Technical Tip

Model: TX-SR803/SR703, DTR-4.6/5.6/6.6/7.6

Subject: High pitched noise is heard in the subwoofer.

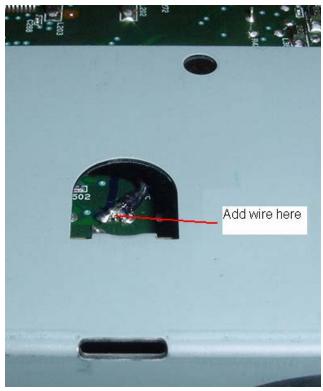
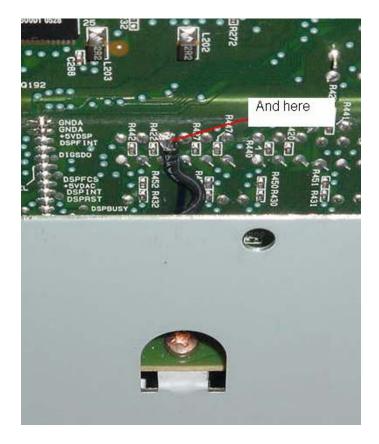
Symptom: A high pitched noise or, a motorboat noise can be heard when using the Optical, Coaxial or HDMI input.

Solution: If the DSP board (U03) is marked NADG-8660-1 (see board version pictures) modify the DSP board as follows: Relocate resistor R175 (470hm) to location R149.

Add a jumper wire to foil side of board between the ground legs of C432 and C442.

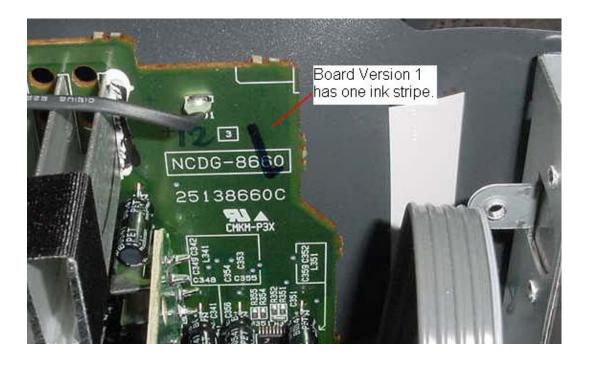
Board version 1 can be identified by the ink stripe marking. One line indicates the board is version one.

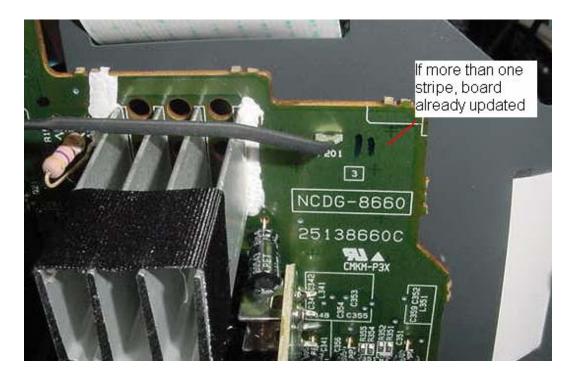
Two or more lines indicate a later revision board.

Note: On later revision boards, R175 is a zero ohm resistor and R149 already has a 47 ohm resistor mounted on the board. In this case, you just need to add the jumper wire.
